DEVELOPMENT REVIEW BOARD <u>Action Sheet</u>

Proposed new Bank Building (Southwest Capital Bank)
Located at the SE Corner of Central Avenue and 15th Street
1410 Central Ave (a.k.a. 120 15th Street) Albuquerque NM 87104

Project # 1009118, Case # 12 EPC 400002

RMKM submitted a site development plan for building permit to the City of Albuquerque's Environmental Planning Commission. The project was approved with conditions on April 12th, 2012. This letter serves to list all changes which have been made to the EPC approved drawings.

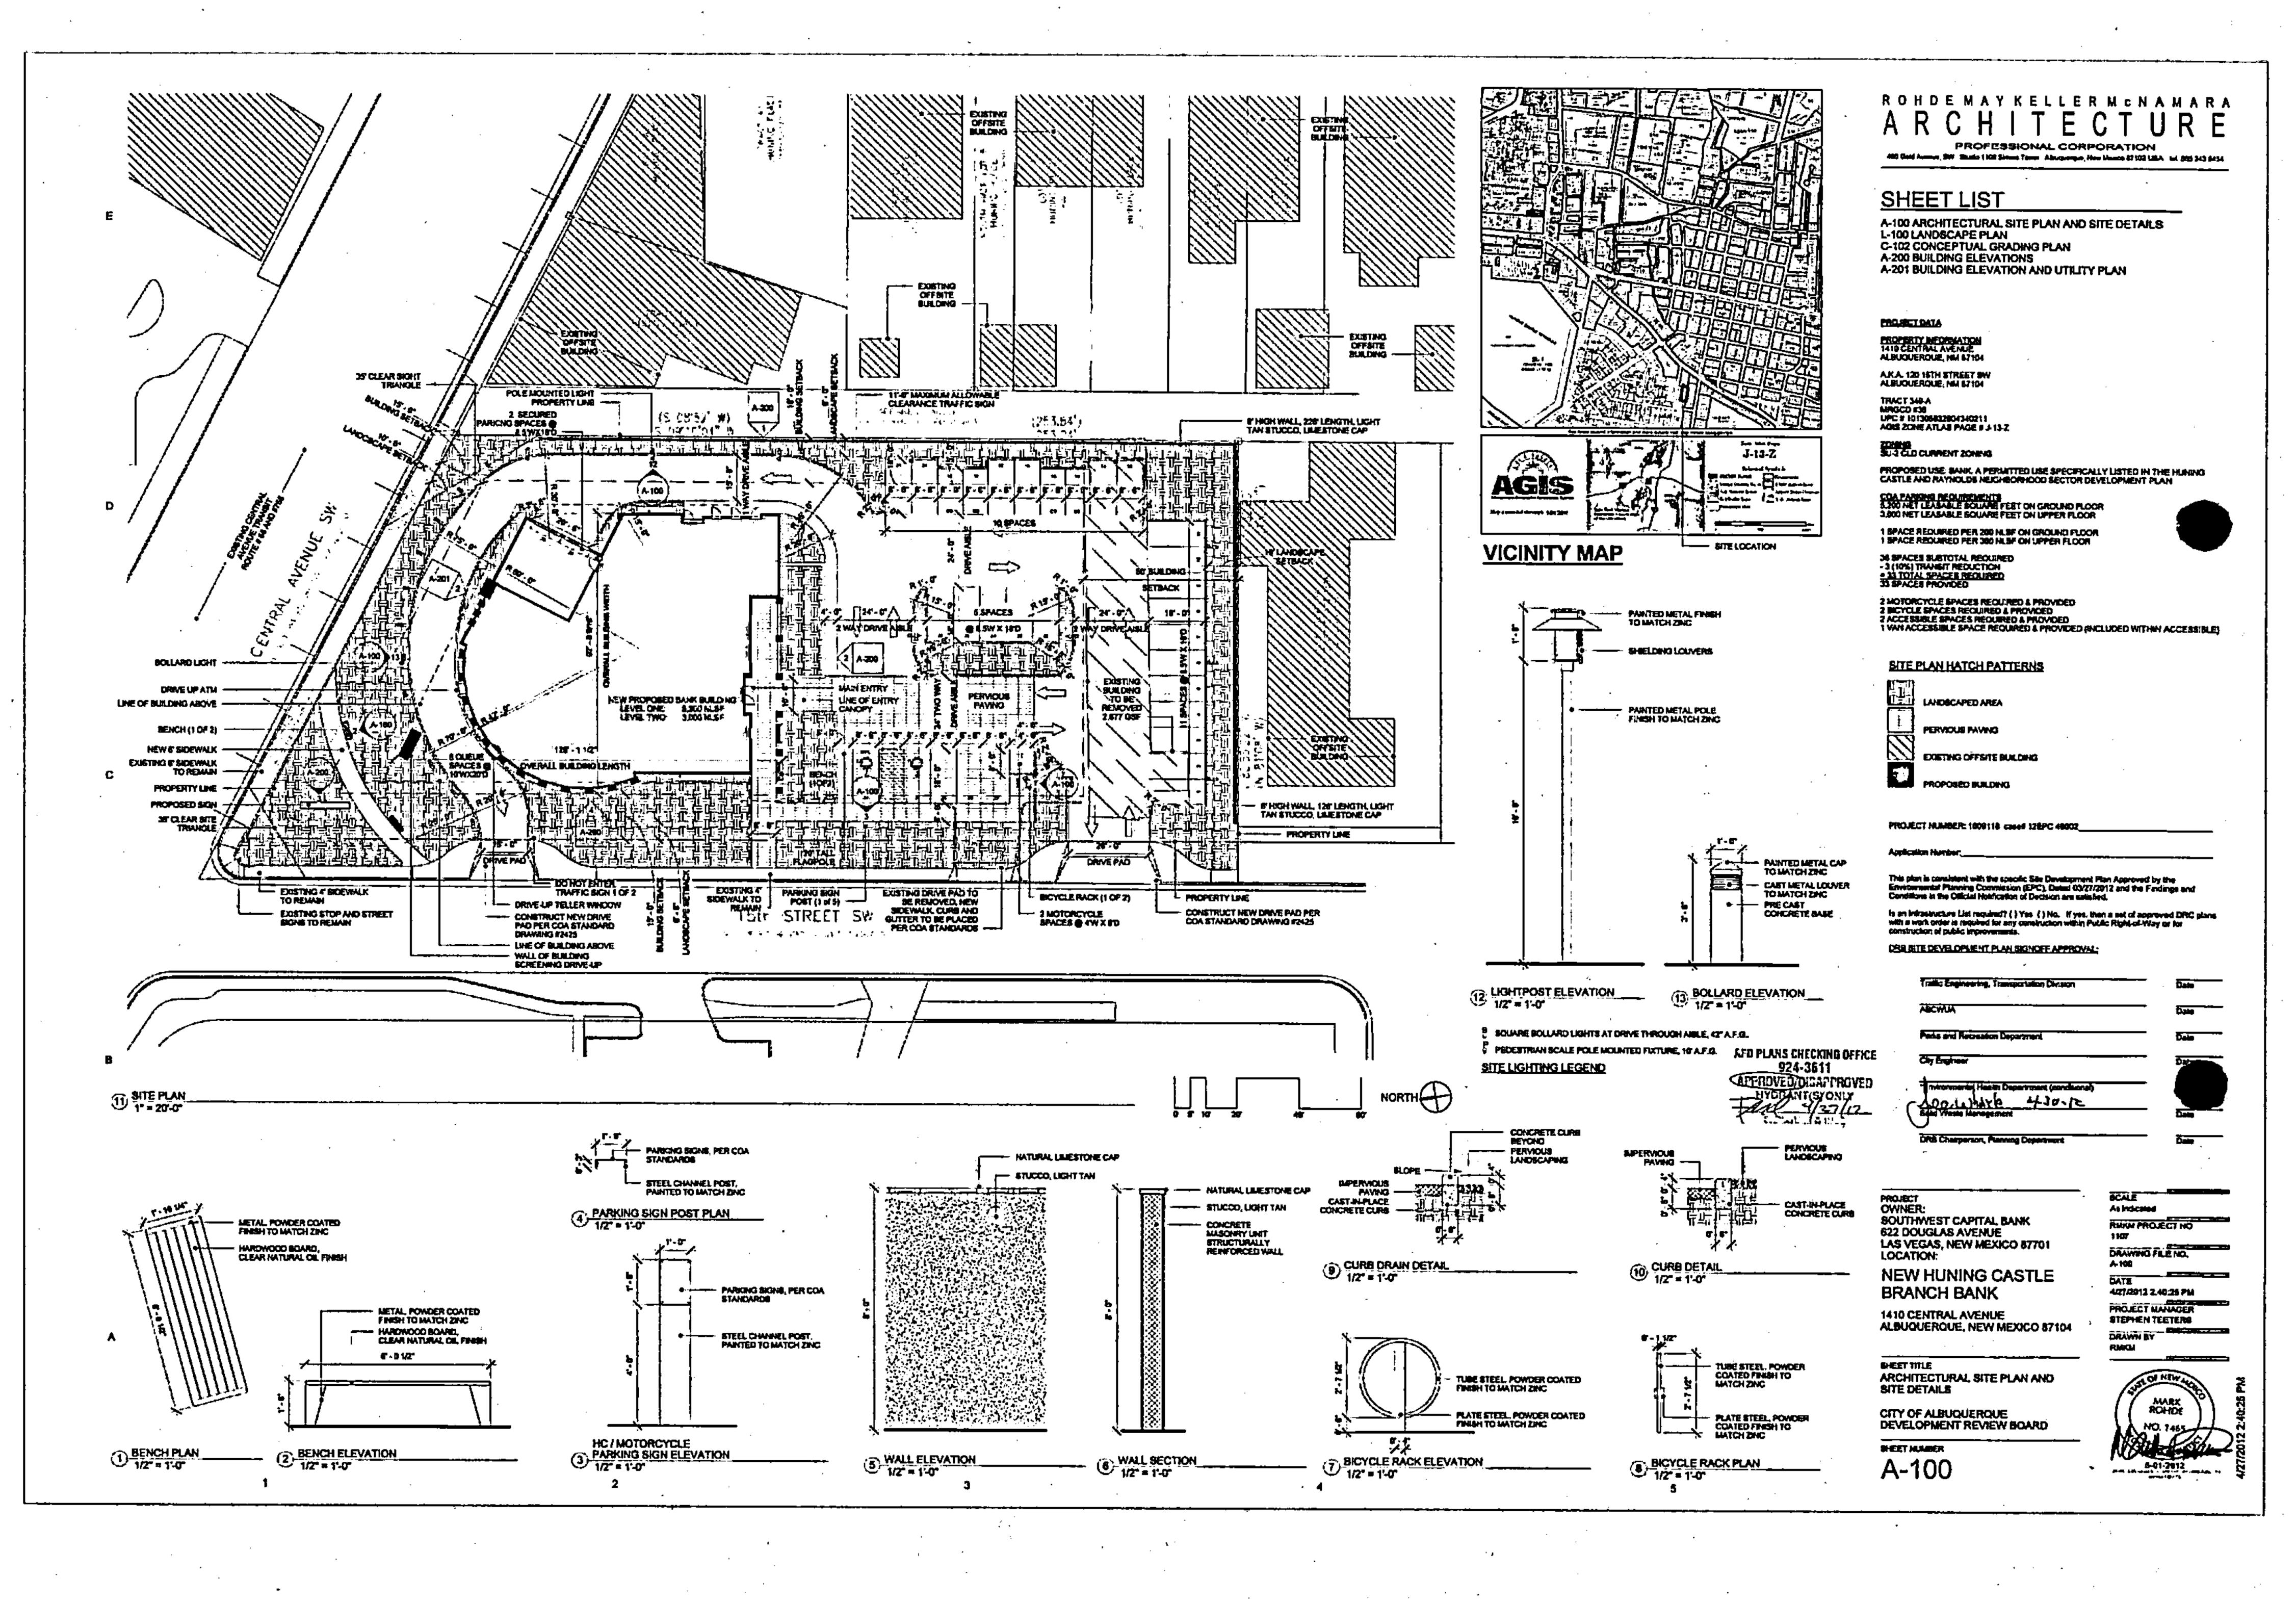
- a. The applicant shall meet the Zoning Code requirement (Section 14-16-3-10) (G)(1)(d) that "At least 75% of the required parking area trees shall be deciduous canopy-type shade trees, capable of achieving a mature canopy diameter of at least 25 feet." The calculation showing 83% deciduous trees in the parking area has been included.

- b. The Plant Schedule on the Landscaping Plan shall contain a category for Water Use for all plants. Landscaping which is high water use shall be avoided. The plant schedule has been modified to include water use, high water usage plants have been avoided.

- c. The ground cover referred to as "Dward plumbago" shall be spelled "Dwarf plumbago." The spelling of Dwarf plumbago has been corrected.
- d. The number of Street Trees "required" and "provided" shall be shown on the Landscaping Plan. The calculation showing required and provided street trees has been provided.

- e. Two additional evergreen trees shall be added to the east side landscaping strip next to the alley, in between the proposed Afghan Pine and Shumard Oaks. Two additional Afghan pines have been added to the east of the parking area.

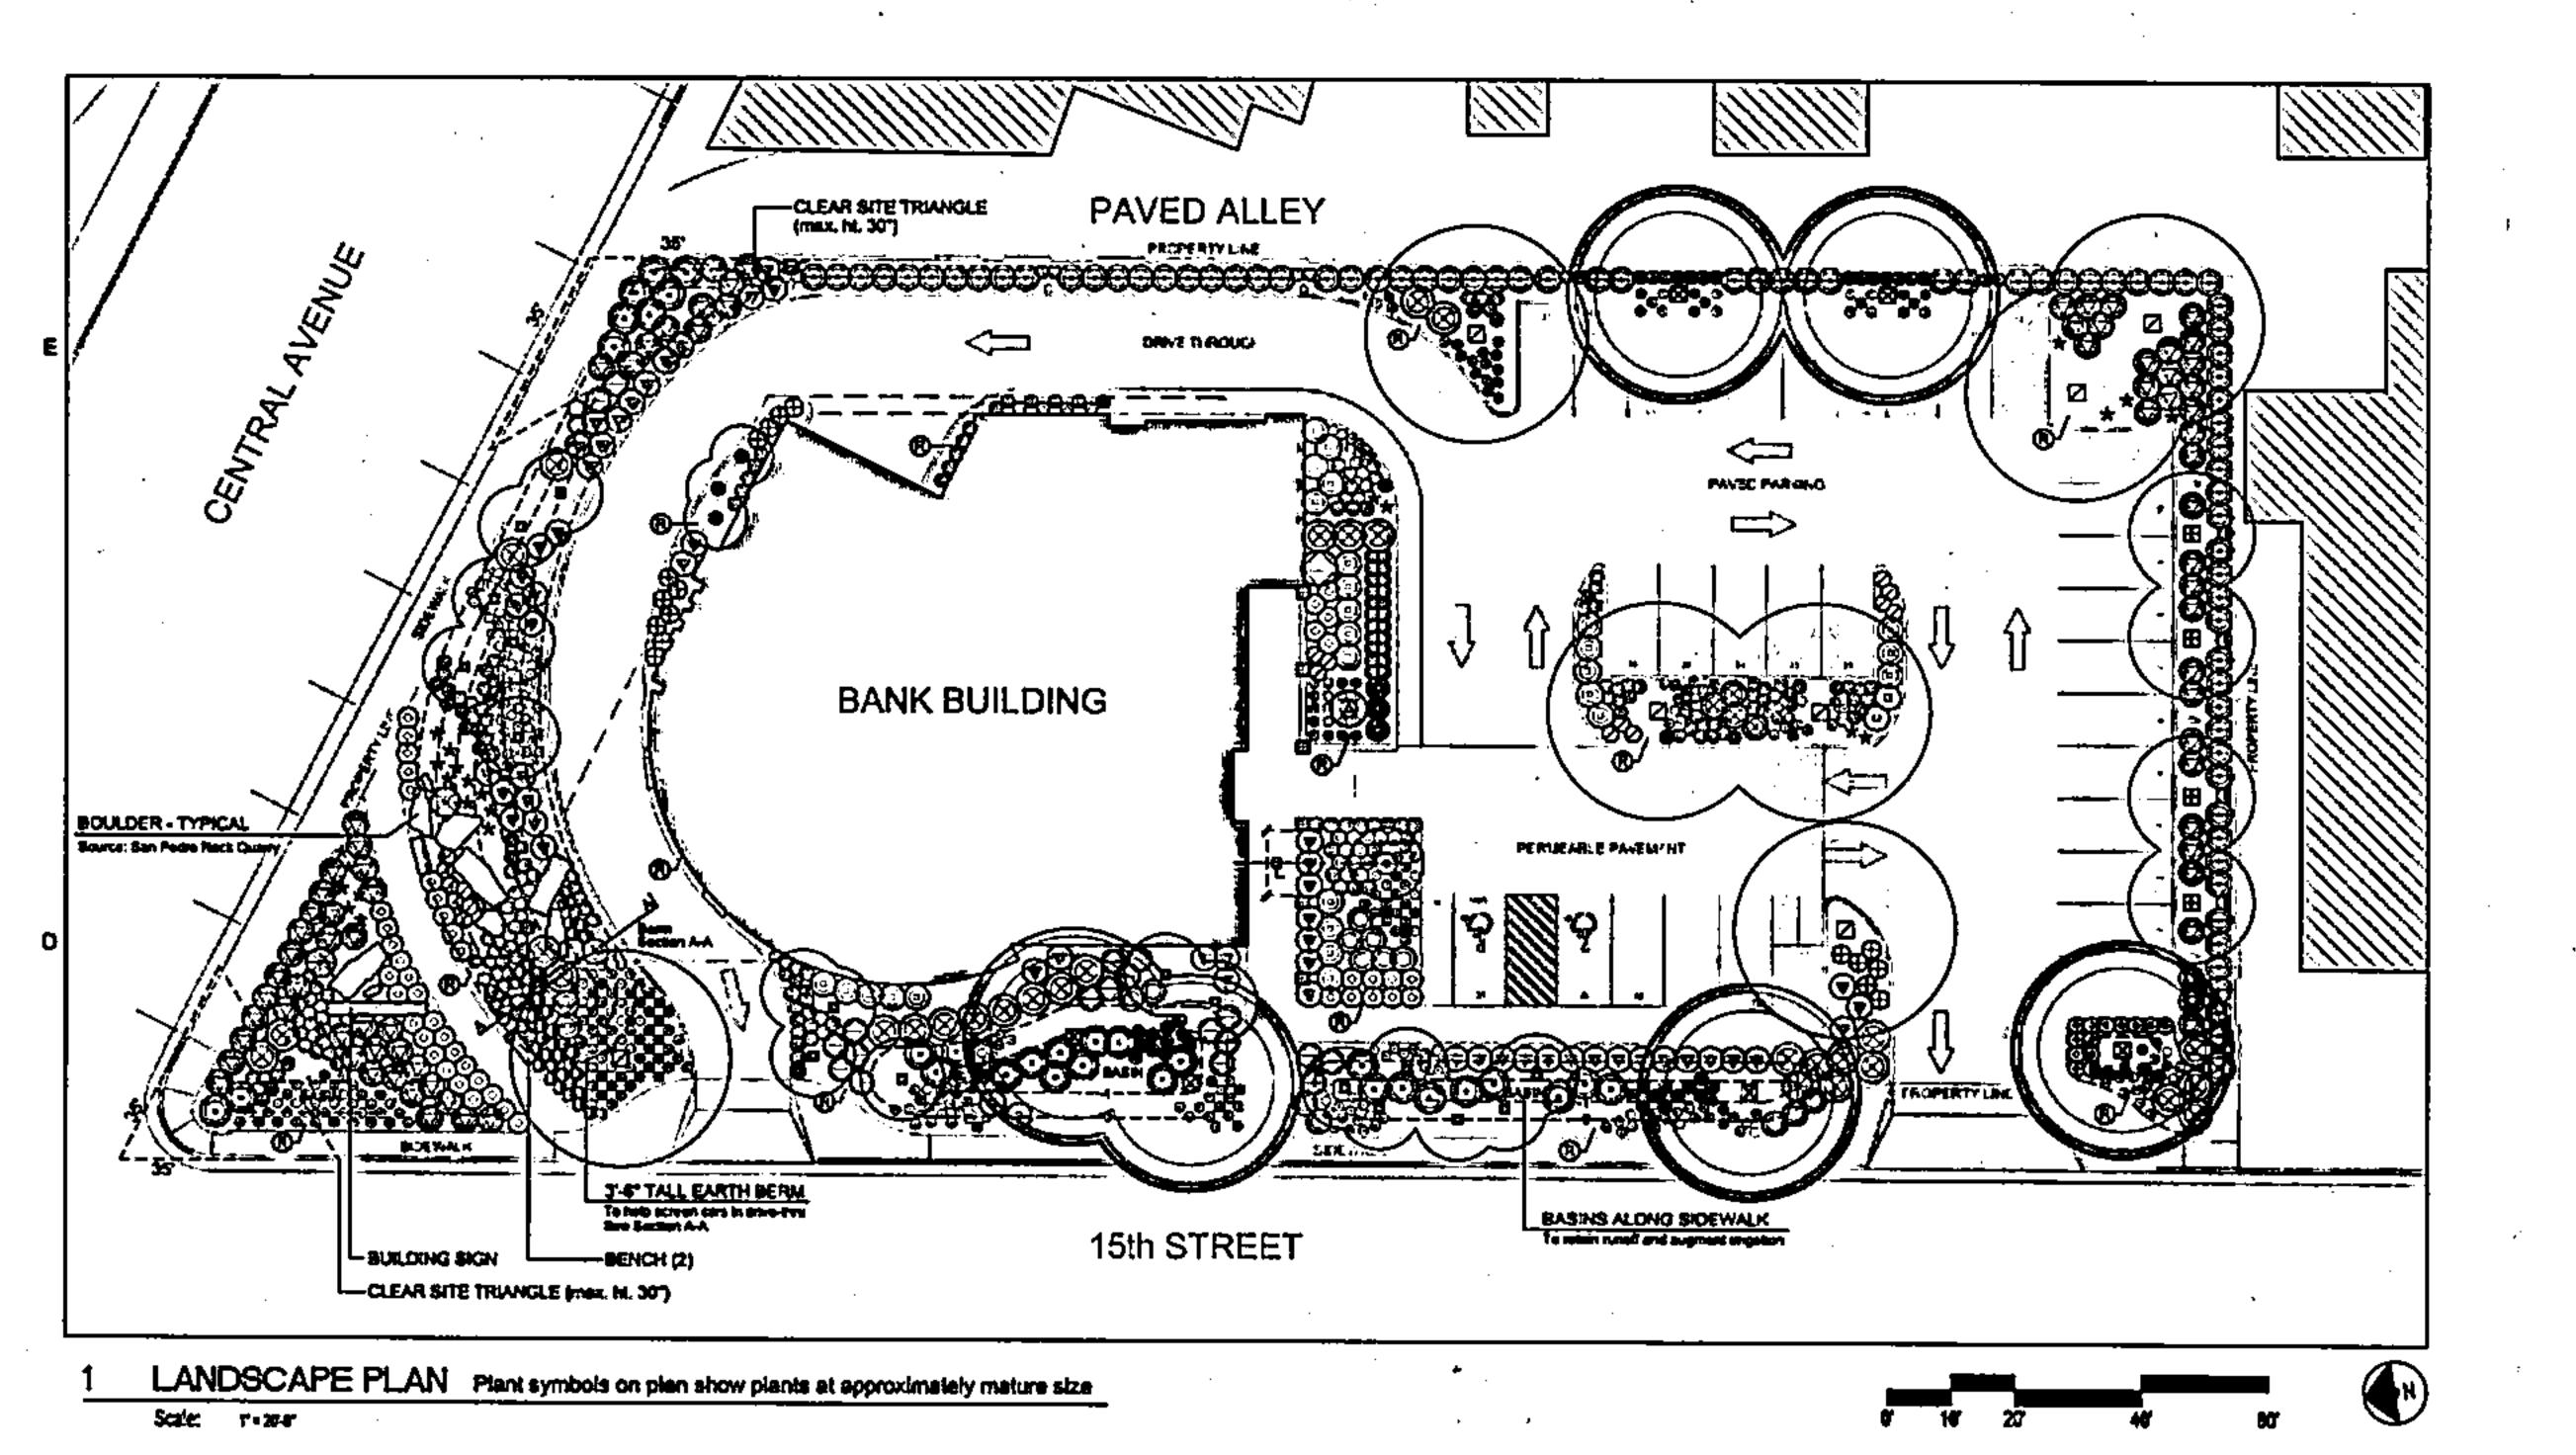
- a. Provide a sight distance exhibit at the existing curb cut along Central. The proposed wall may need to be lowered in this area. A 35' clear site triangle is indicated with revised plantings of a maximum 30" height.

- b. Pavement markings and signage must be provided for the drive through exit. One way pavement markings are indicated and do not enter traffic signs are indicated at the drive through exit.

- c. Define the maximum allowable clearance where the building overhangs into the drive through. Signs must be provided. A 11'-0" maximum allowable clearance traffic sign has been indicated at the drive through lane entrance.

- d. Provide a legend defining all hatching and linetypes. A hatch legend has been included and the linetypes are labeled.
 - e. Is the sidewalk flush with the parking lot? If not, ramps will be required. Yes the sidewalk is flush.

- f. Site plan shall comply and be designed per current DPM standards/ requirements. OK
